Re: 2804 SW Hearthstone Place
Lot 55, Hook Farms
Lee's Summit, MO 64082

Apex Engineers Inc. observed the house under construction at the above-referenced address. Our firm has been retained to address comments from the city rough-in inspection. For the purposes of this report, the house will be referred to as facing north.

Figure 1.0 – Notched Joist Plate Repair

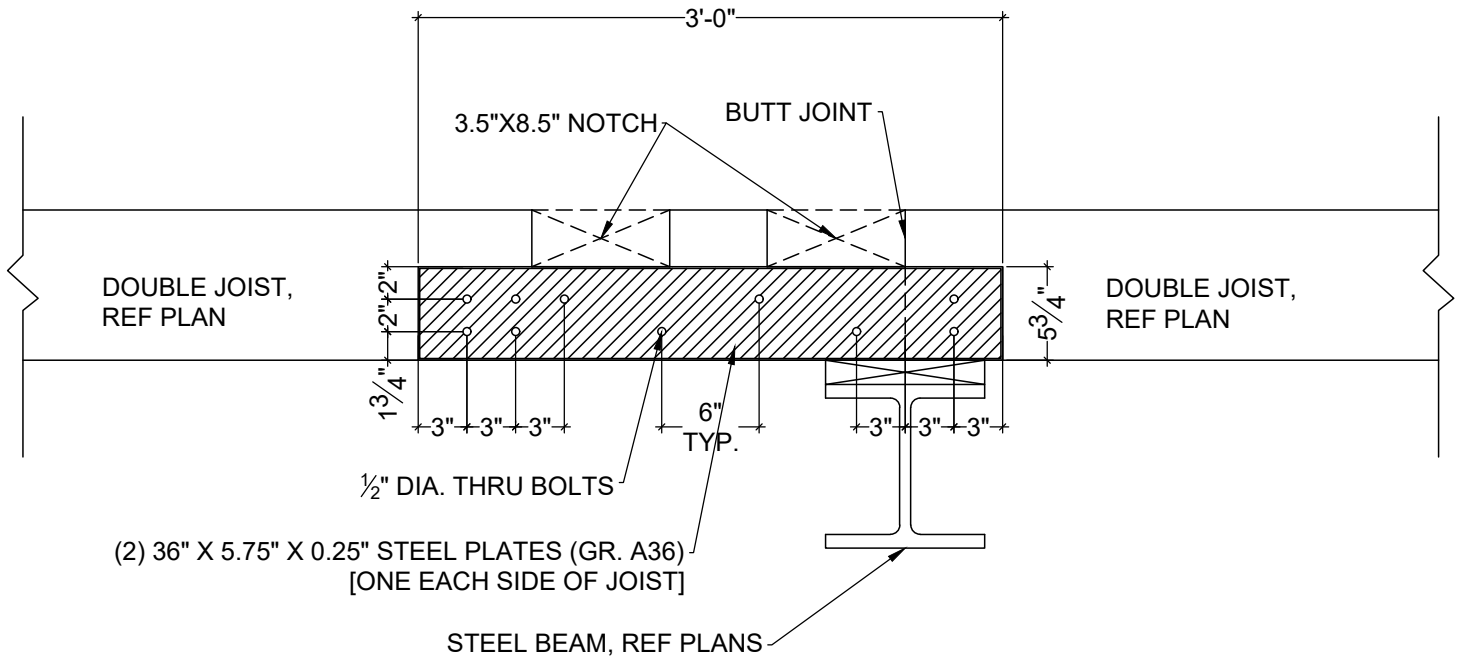
1. *The beam splice is located above the column at the bottom of the stairs. Is this okay? Plans show it floating approx. 3' off bedroom wall in front of the bar area.*
 - After computations, our firm has determined that the splice is in an acceptable location.
2. *There is an over-notched joist above the basement bath entry.*
 - Two (2) 3.5"x8.5" square notches were observed on the top edge of a doubled joist and located approximately 2'0" from steel beam support. The observed notches are **not** acceptable. The joist shall be repaired per the following:
 - (2) 36"x5.75"x0.25" steel plates (Gr.A36) shall be installed and bolted per figure 1.0.
 - One plate shall be installed on each side of the notched joist.

Figure 2.0 – Notch Repair with CS Strap

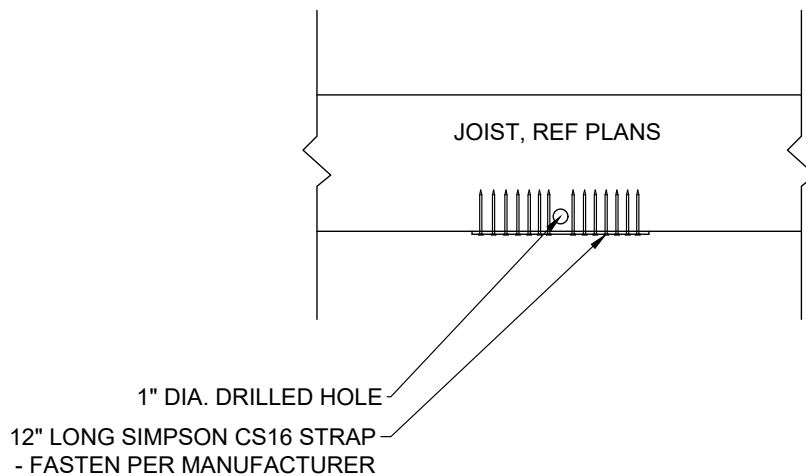
3. *Holes drilled in joists too close to each other at the electrical service panel.*
 - Drilled holes were observed too close to the bottom edge of the joist, taking the effective depth of the joist to 7". After computations, our firm recommends installing an additional full-length ply with the maximum possible depth without interfering with electrical (#2-2x4 DFL or #2-2x6 DFL) and fastened per the beam fastening schedule per detail 10/S3.1 of city-approved plans.
4. *Holes drilled in joist above the entry to bedrooms from rec room too close to the edge.*
 - Vertical 1" diameter holes were observed in triple #2-2x10 joists.
 - After computations, our firm has determined that the holes are acceptable.
5. *Hole too close to the bottom – near basement door and bedroom hall entry.*
 - 12" long Simpson CS16 strap shall be installed centered under the hole. Reference figure 2.0.
